**BC Timber Sales
Albreda 2015
Visual Assessment and Recommendation
RDI Resource Design Inc**

Blocks Investigated November 19, 2015 (update):

Notes for Current Proposal Assessment 151119

Current Proposal - Viewpoint 1731.2 - 151119

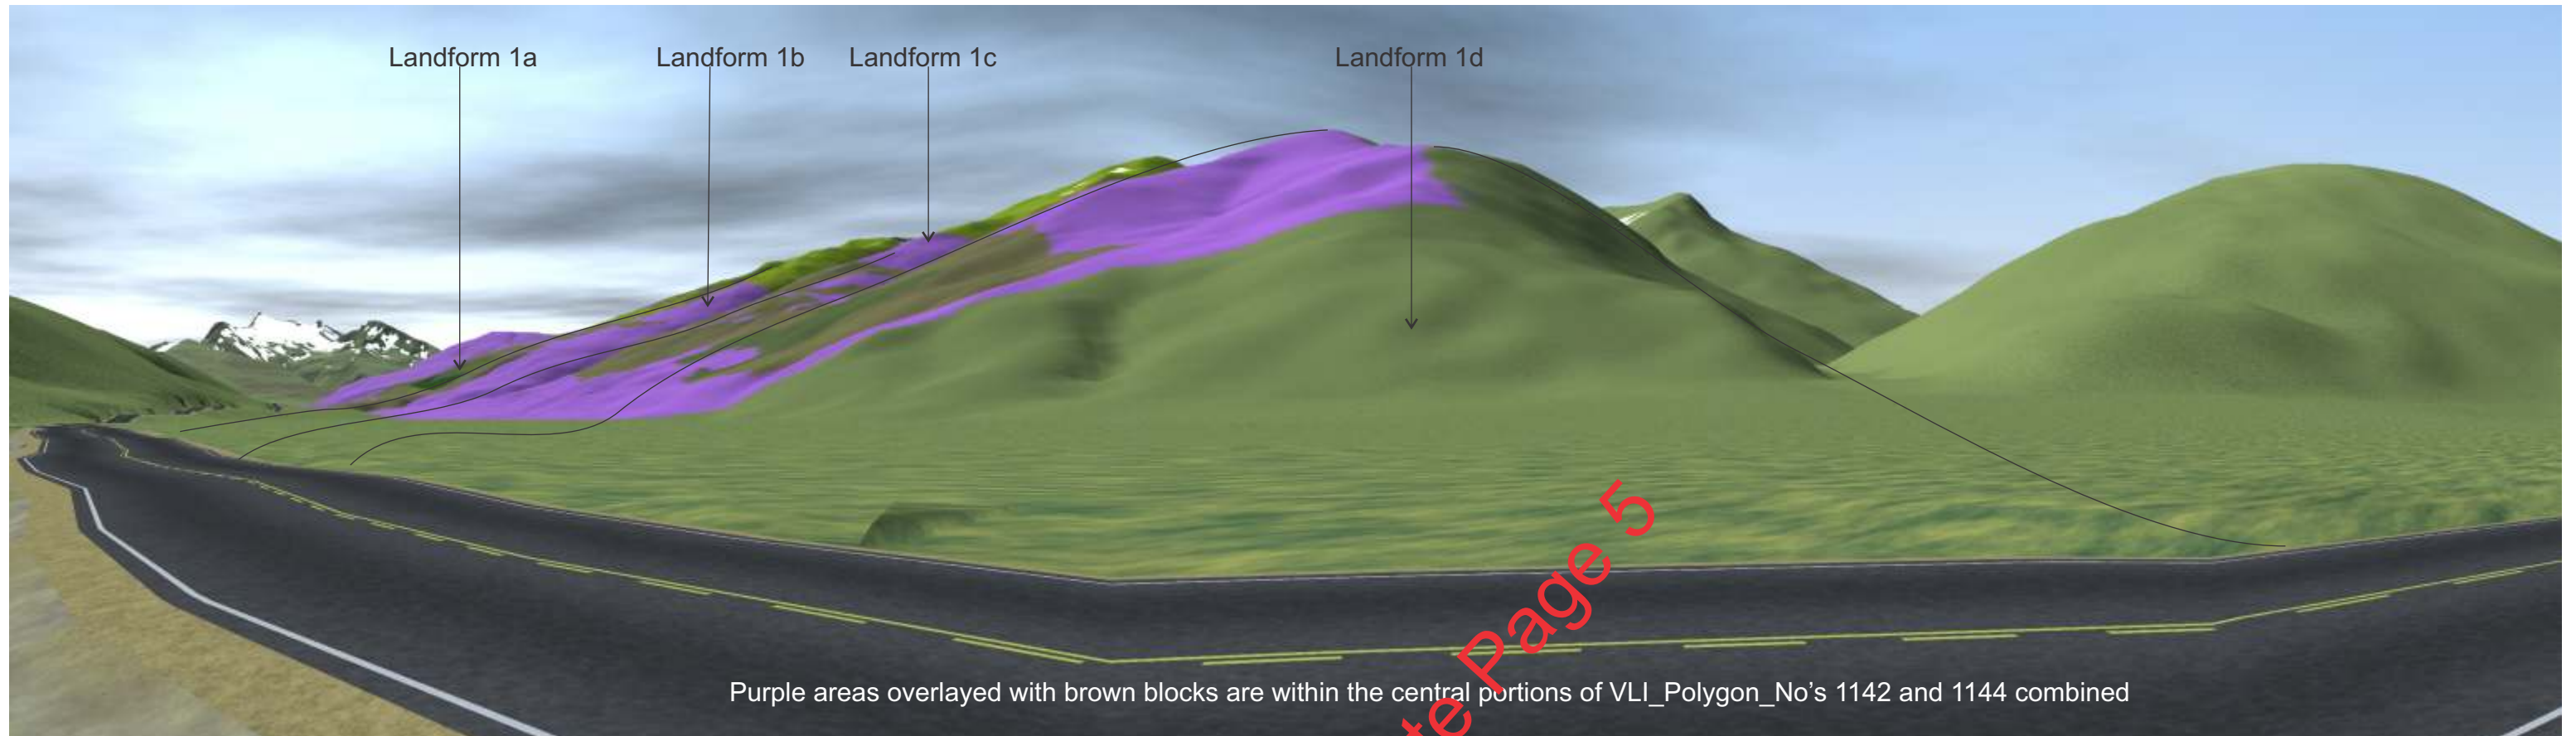
Purple areas overlaid with brown blocks are within the central portions of VLI_Polygon_No's 1142 and 1144 combined

****See current proposal on Page 5 demonstrating significant scale reductions and design improvements****

Current Proposal - Viewpoint 1733 - 151119

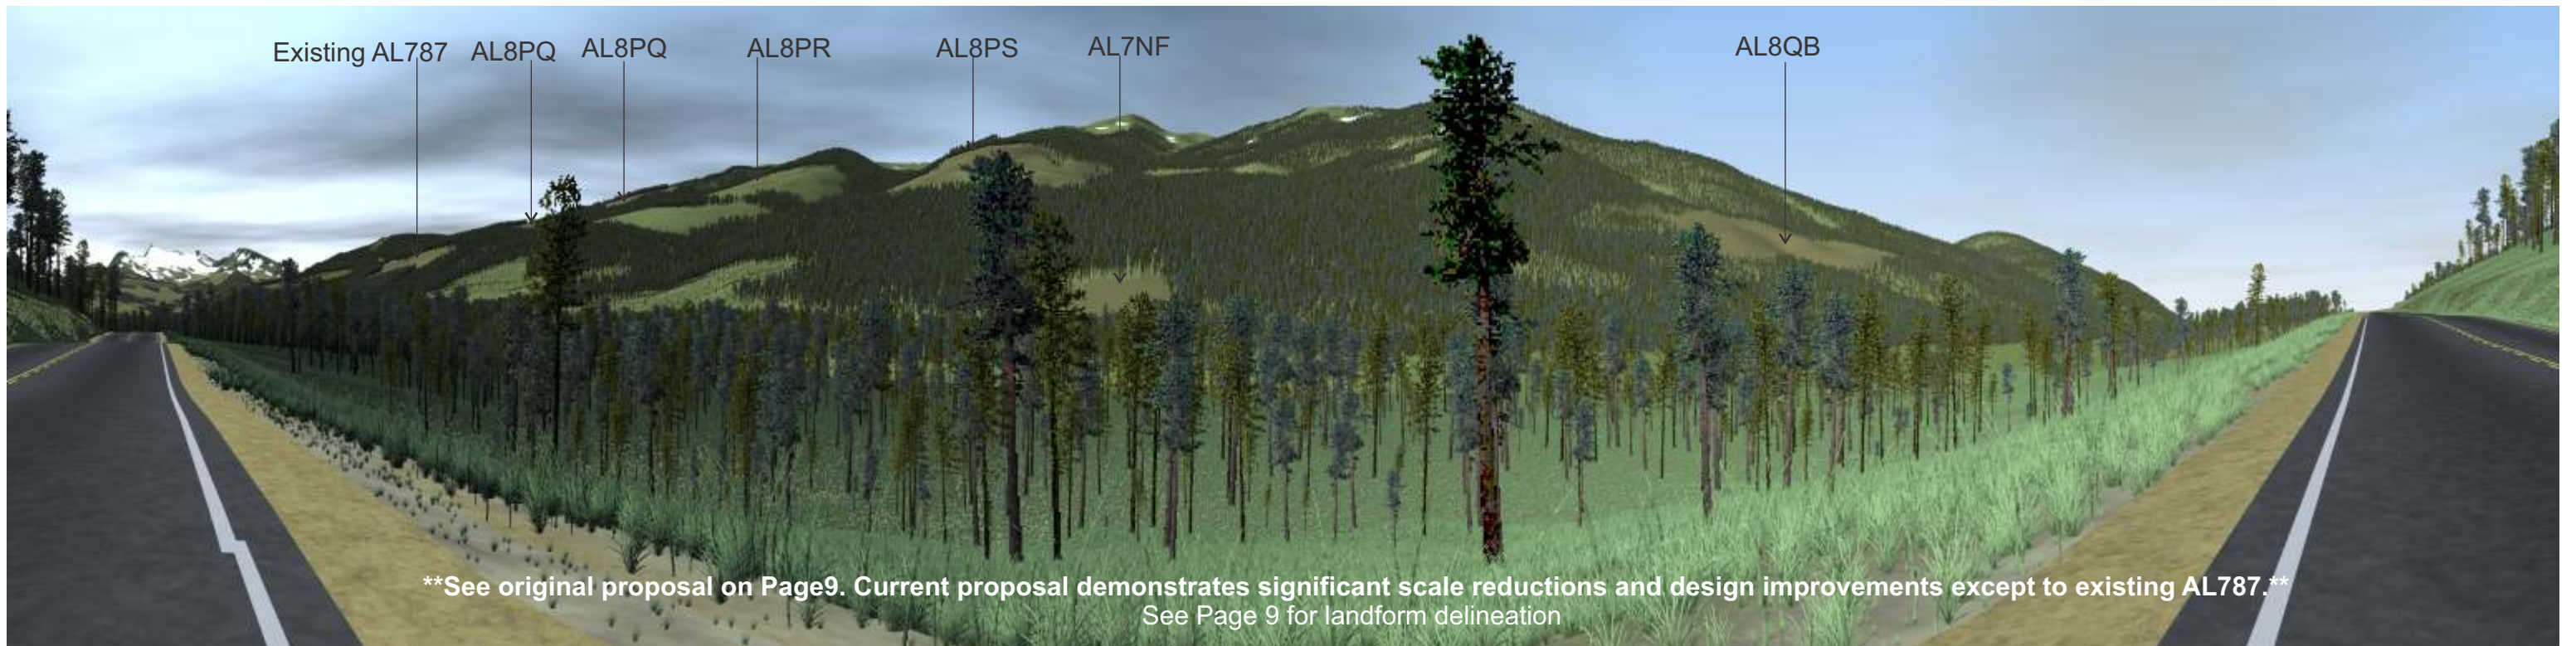
****See original proposal on Page9. Current proposal demonstrates significant scale reductions and design improvements except to existing AL787.****
 See Page 9 for landform delineation

Original Proposal - Viewpoint 1733 - 150919

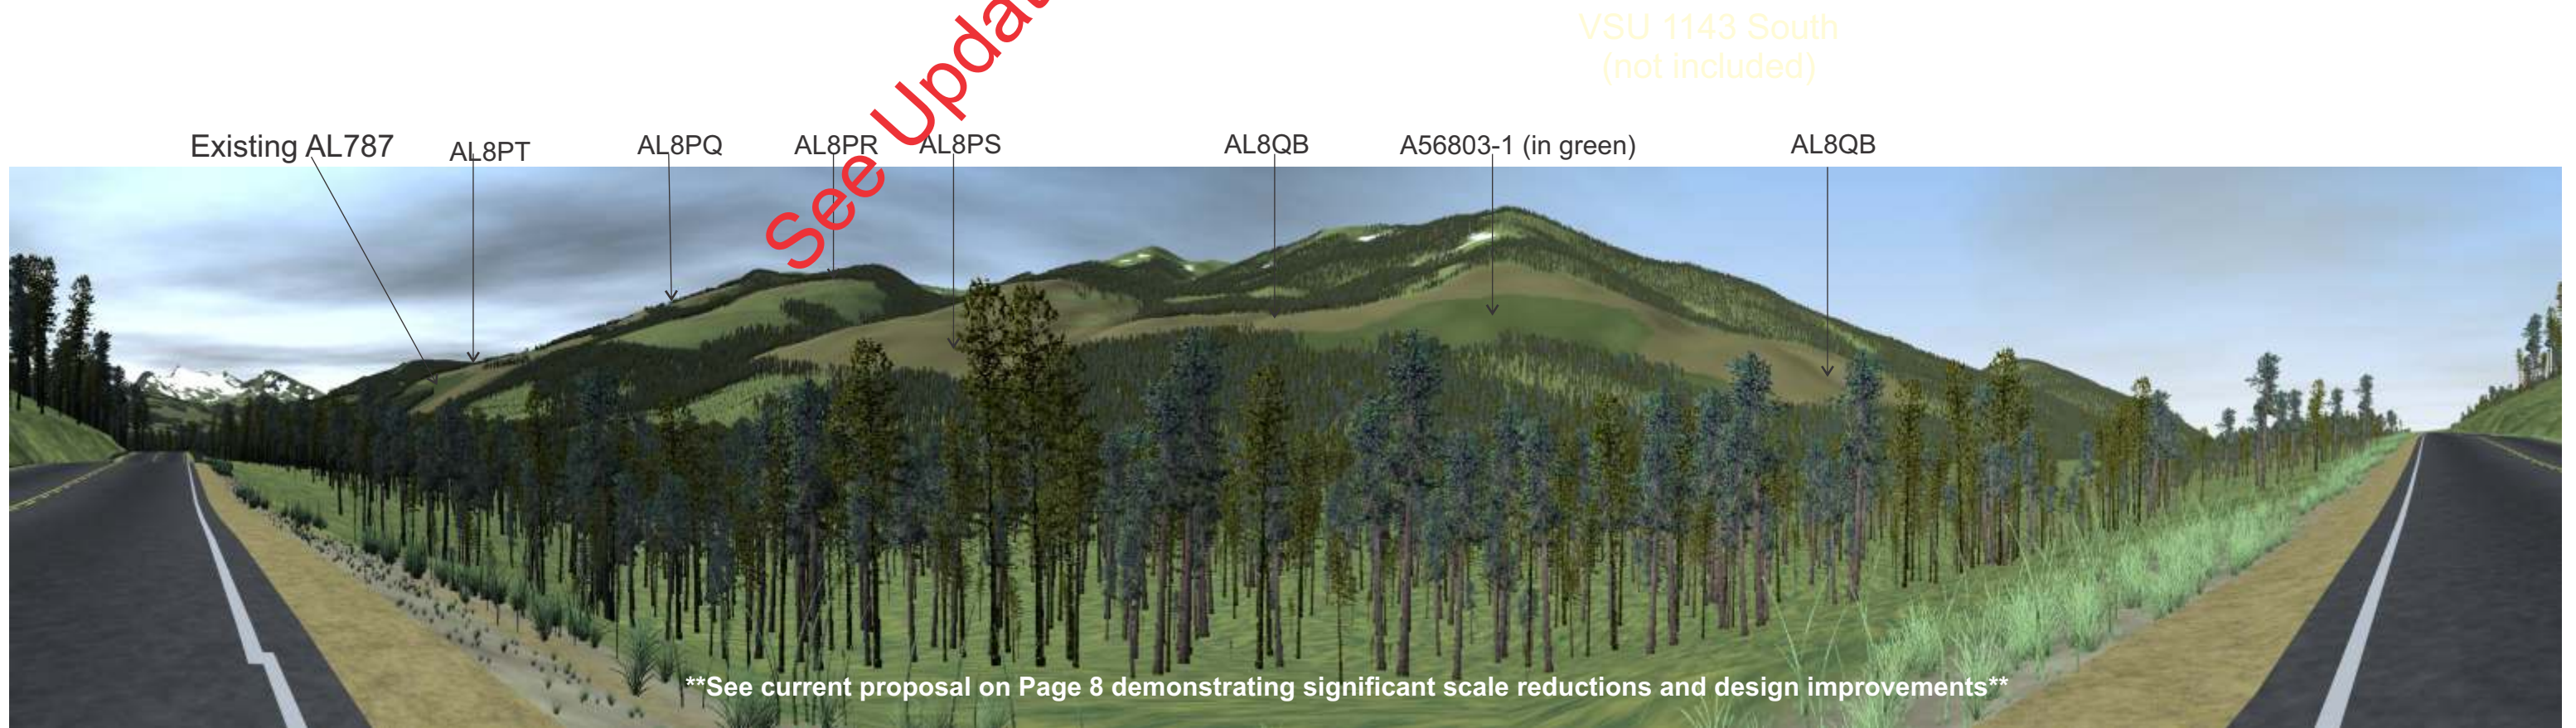
****See current proposal on Page 8 demonstrating significant scale reductions and design improvements****

Proposed blocks are in light brown colour except light green for A56803-1

Current Proposal - Viewpoint 1734.5 151119

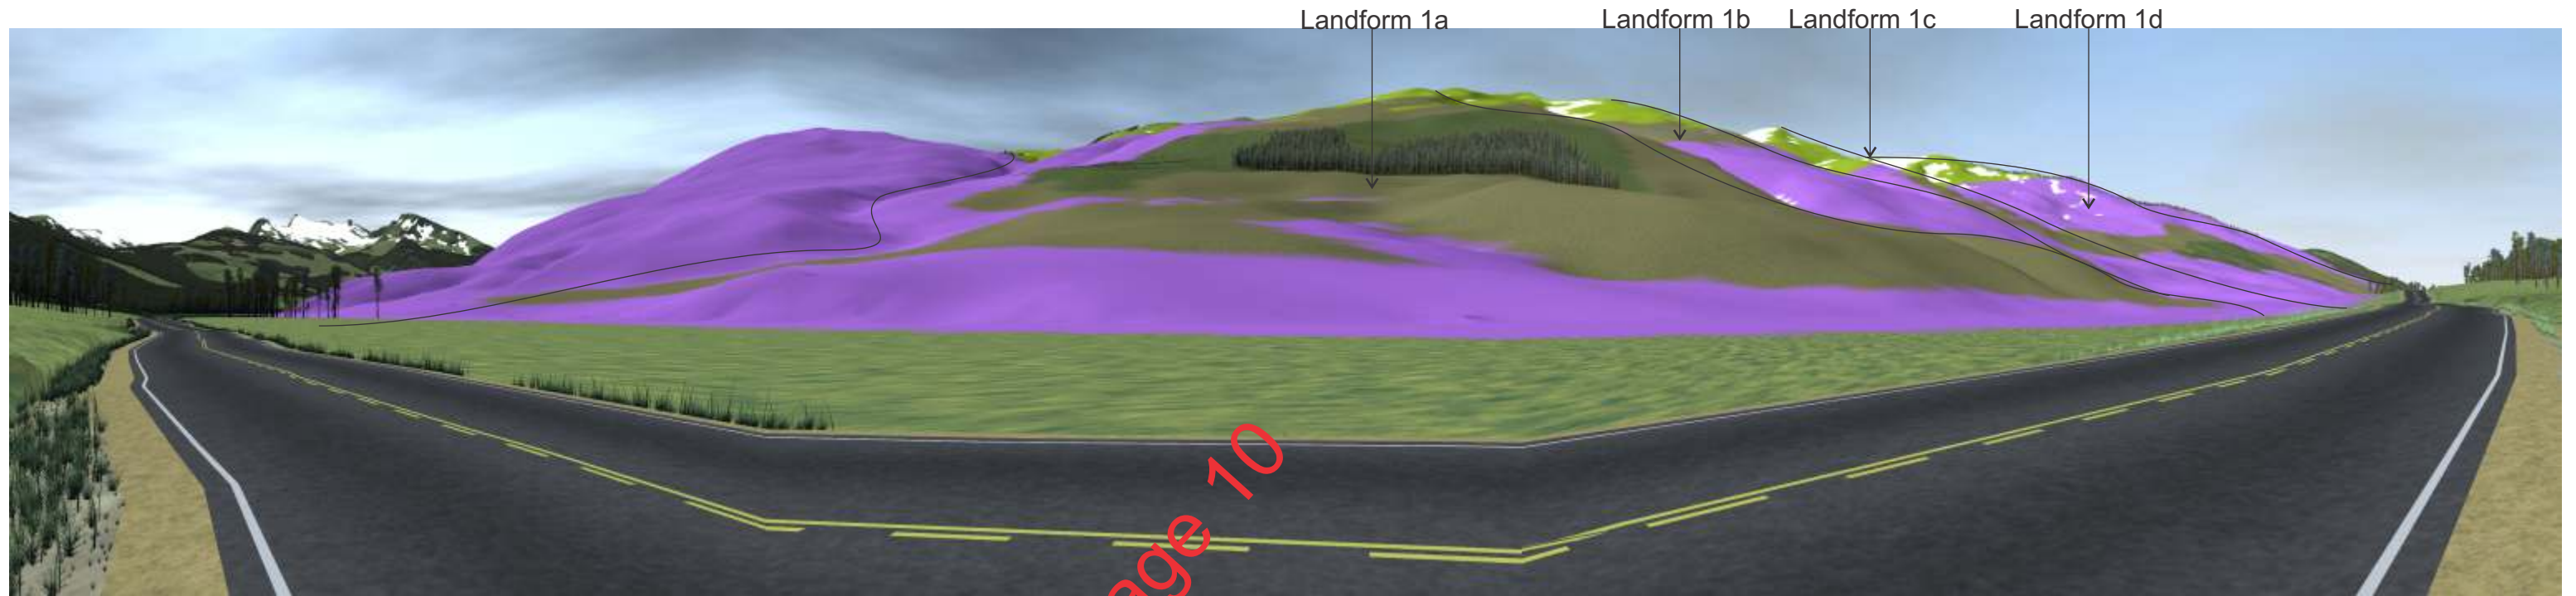
Existing AL787 as provided in BCTS shapefile - appears larger on left side in rendering compared to photo).

****See original proposal on Pages 11 and 12. Current proposal demonstrates significant scale reductions and design improvements except to existing AL787****

Viewpoint 1734.5 - 150919

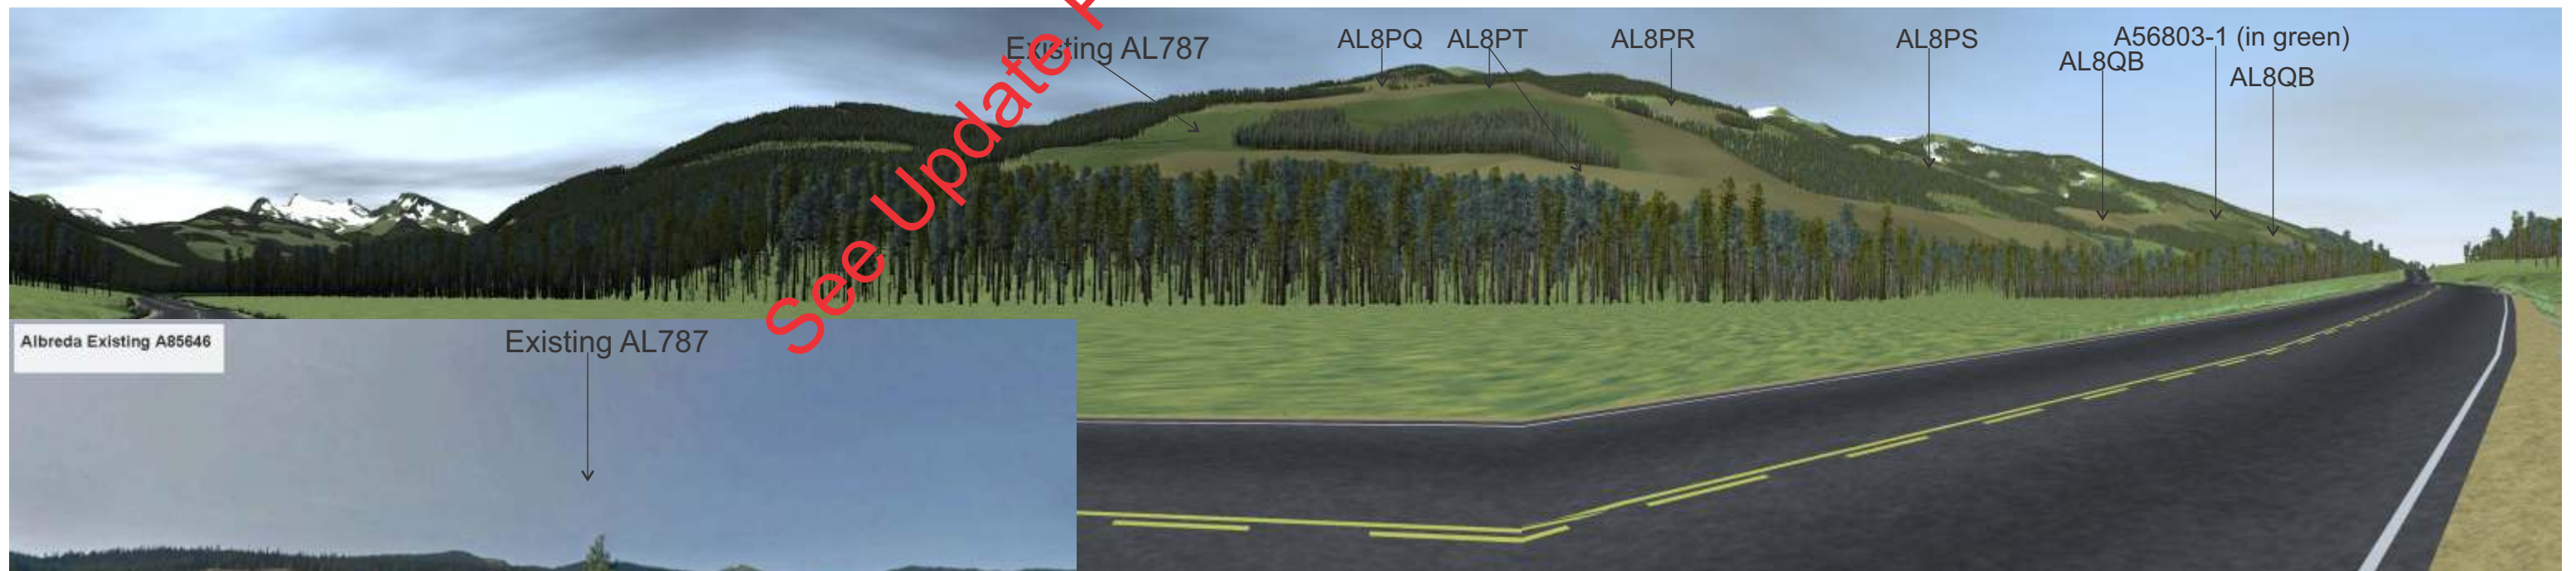
Existing AL787 appears larger on left side in rendering compared to photo). See next page for images by block.

****See current proposal on Page 10 demonstrating significant scale reductions and design improvements****

Original Proposal - Viewpoint 1734.5 - Individual Blocks

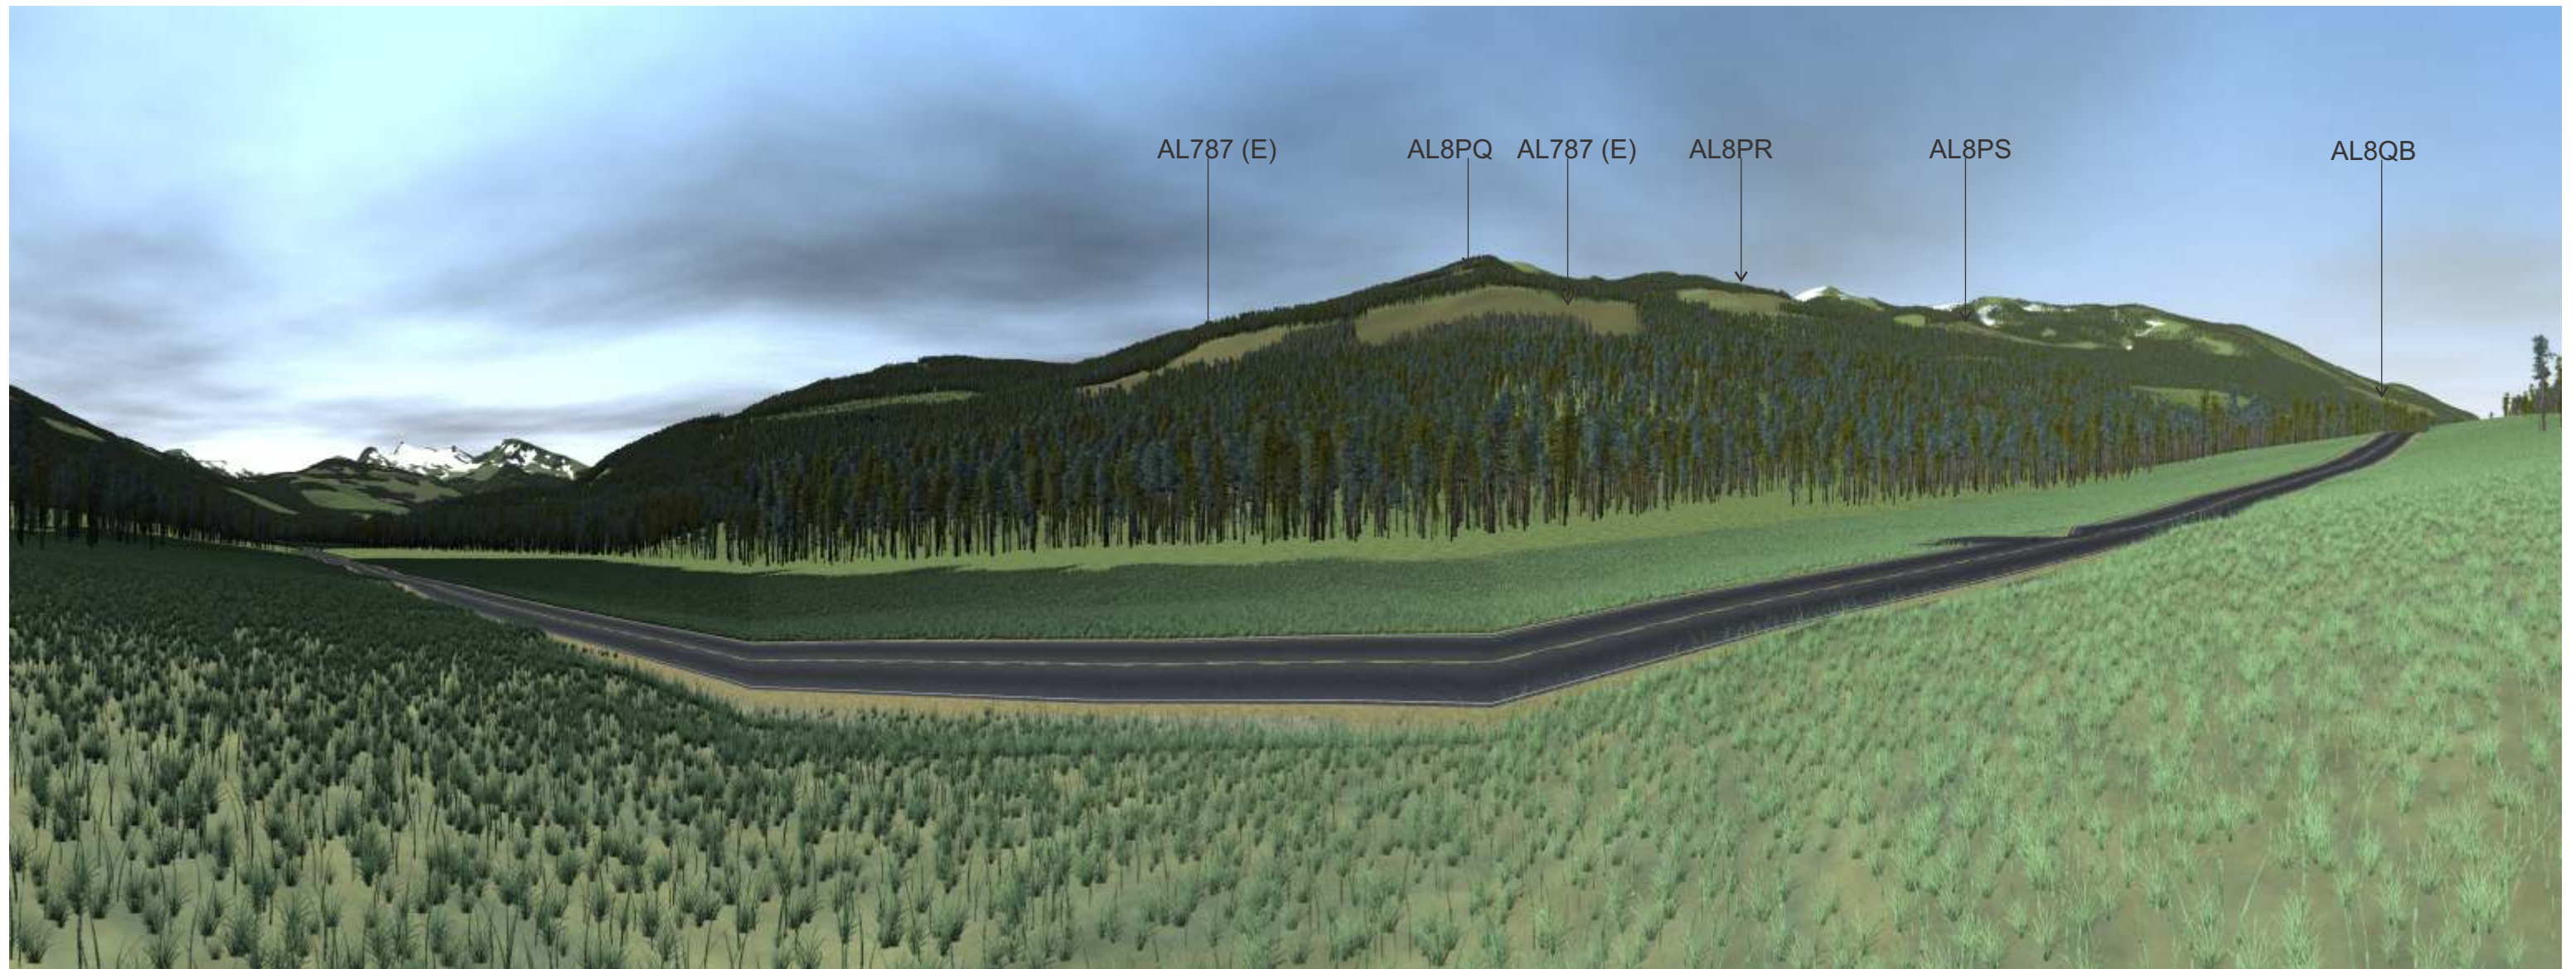
****See original proposal on Pages 11 and 12 from 1734.5. Current proposal demonstrates significant scale reductions and design improvements except to existing AL787****
